Canopy Retention Analysis

Ladera Vineyards Winery
Minor Modification P21-00294-MOD and Viewshed P22-00109
Planning Commission Hearing May 3, 2023

Re: Ladera Vineyards Minor Modification– Response to Napa County comments on biological resources (File # P21-00294)

Figure 1. Land Cover

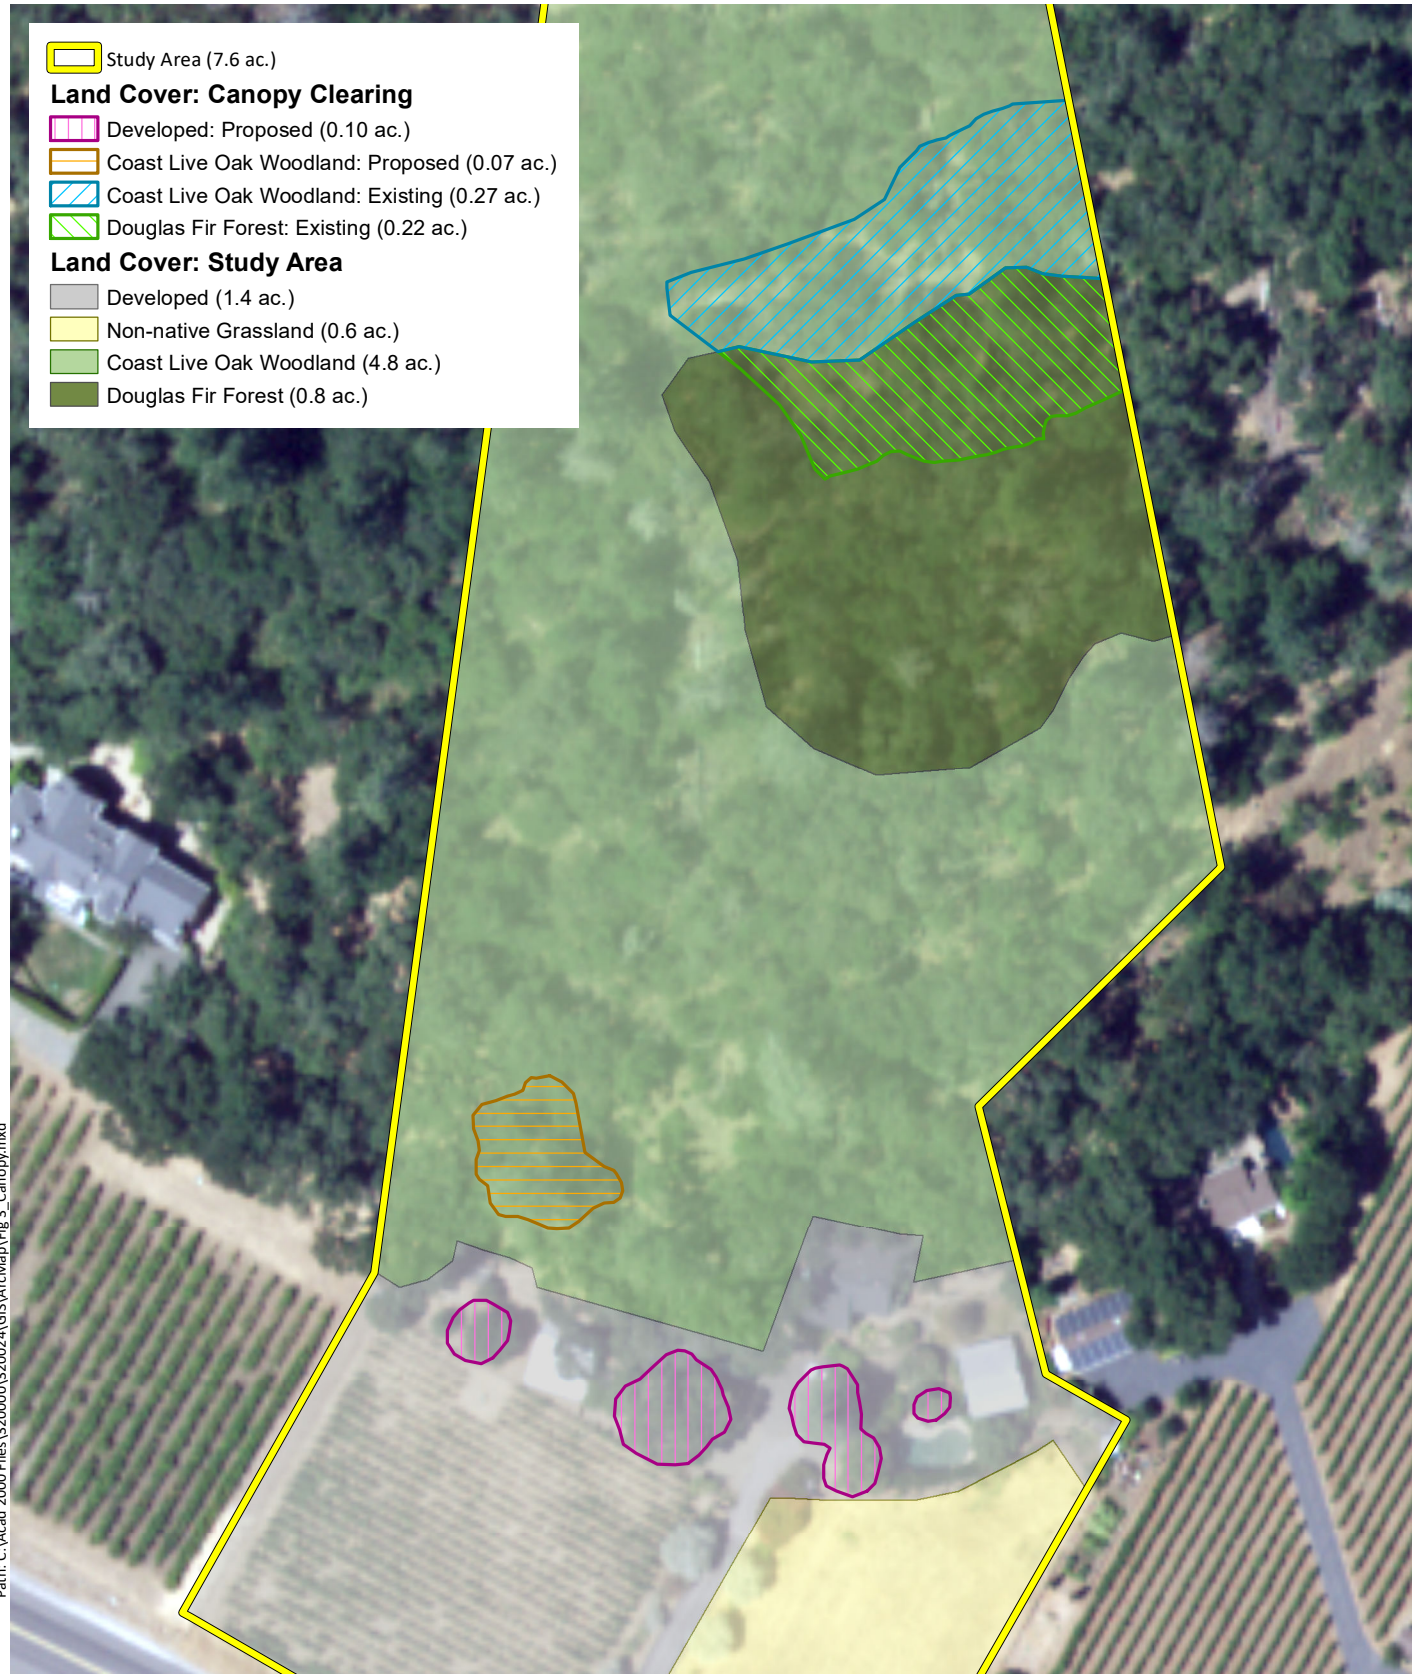
1. Pursuant to NCC Chapter 8.80.135 (Conservation regulations for fire-damaged properties and fire-damaged vineyards), the vegetation canopy cover analysis occurring on a fire-damaged property in the AW shall be based on the existing vegetation canopy cover as configured on the parcel existing on June 19, 2018. . . . Please revise accordingly. (p. 6)

For consistency, a revised land cover figure using a 2018 baseline aerial is included in Attachment A. As suggested in the full version of the County's comment, there are no notable differences in the extent of on-site canopy between the two aerials (2016 versus 2018) and thus WRA's mapping is unchanged.

Figure 2. Canopy Preservation Area

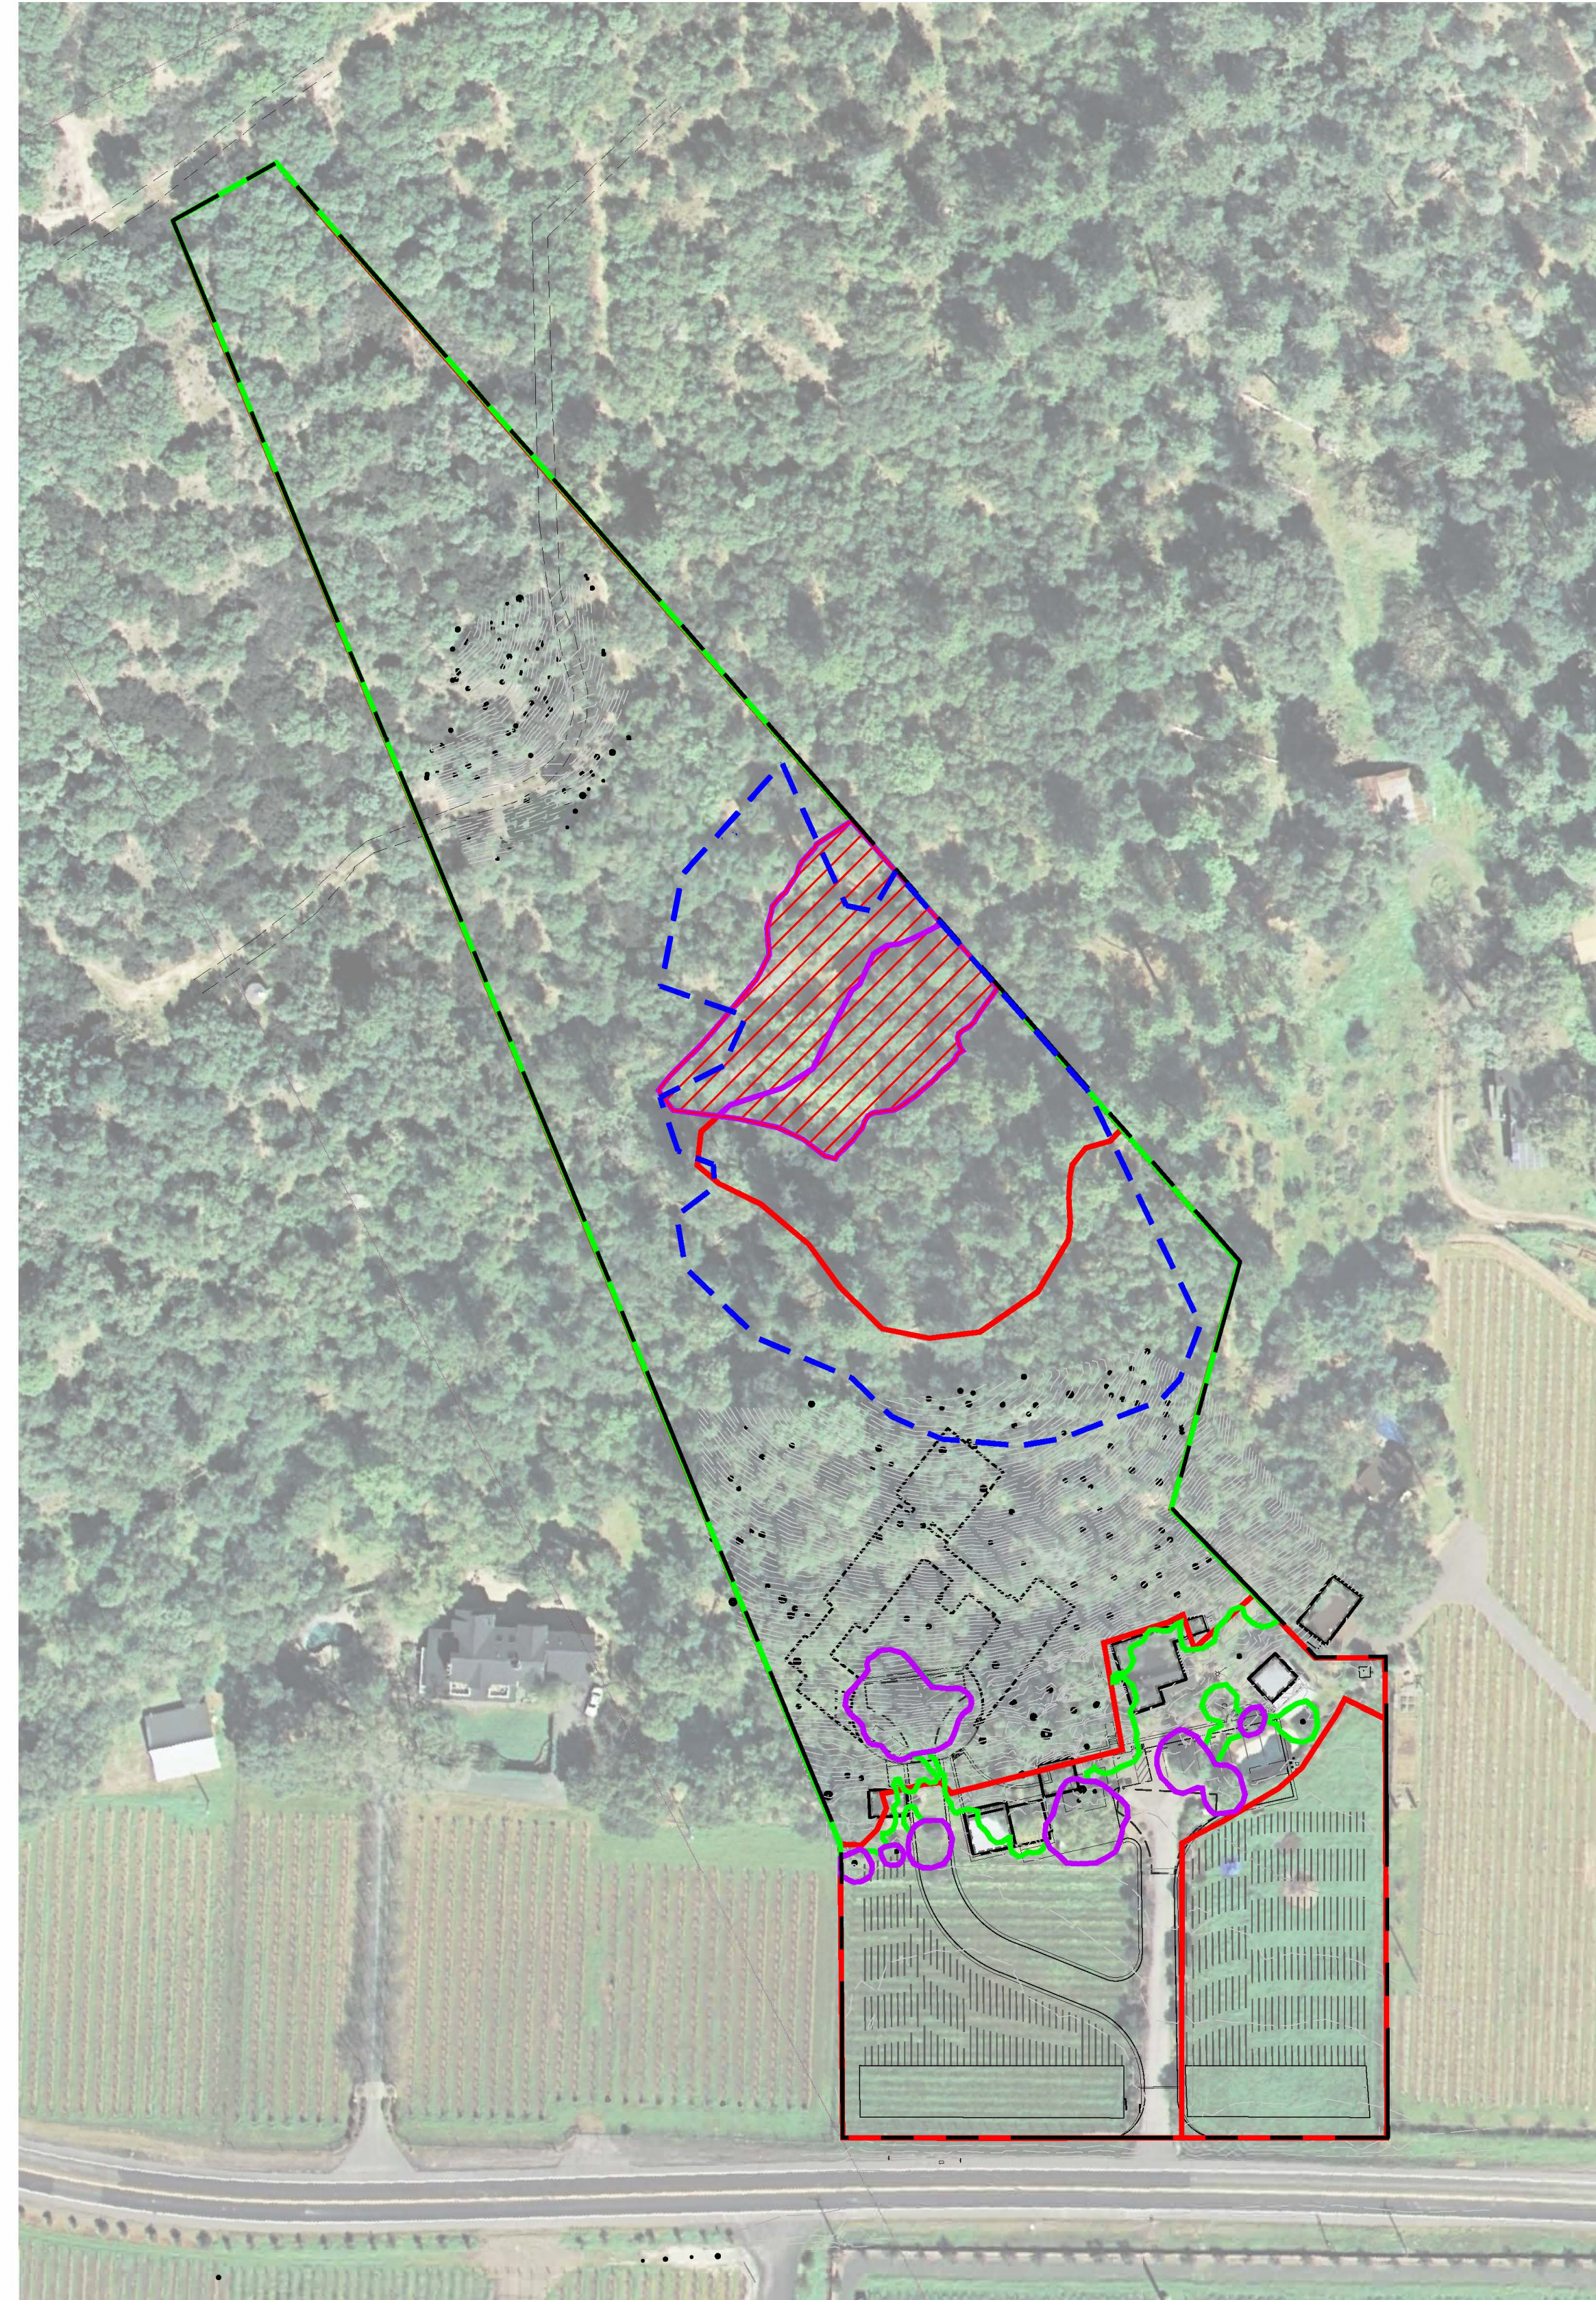
3. NCC Chapter 18.108.020(D) requires that any vegetation canopy cover removed by the project and/or since baseline be mitigated at a 3:1 ratio by acreage. . . However, the same subsection of the code requires that the location of the permanent replacement or preservation be prioritized as listed, including 1) on-site on lands with slopes of 30% or less and outside of stream and wetland setbacks; and 2) if cannot be reasonably accomplished under (D)(1), on-site preservation may occur on slopes up to 50% that results in the highest biological and water quality protections. Please identify the proposed 3:1 mitigation preservation area per NCC Chapter 18.108.020(D). (pp. 6-7)

An area of oak woodland and Douglas fir forest proposed for preservation, overlain with both mapped land covers and percent slope on the property, is shown in Figure 2 (Attachment A). This preservation area has been identified in part via feedback from the County and constitutes the required 1.8 acres. The area is sited to specifically include the largest portion of the property where average slope is 30 percent or less and canopy is currently or was recently present. (There are no wetlands or streams within the Study Area, so avoidance of setbacks to such features are not relevant.)

The proposed preservation area includes the bulk of the approximately 0.5-acre cleared area which featured both Douglas fir forest and oak woodland. Although canopy was removed in this area (after 2018), the substrate was not meaningfully altered, and the area remains surrounded by existing forest/woodland. The area currently supports successional shrubbery, and native trees will presumably naturally recolonize the area over time if allowed to do so. The subject preservation area will feature relatively low perimeter-to-area ratio (reducing exposure of the interior to edges), resulting in one block that is directly contiguous with existing canopy on the property to the east.
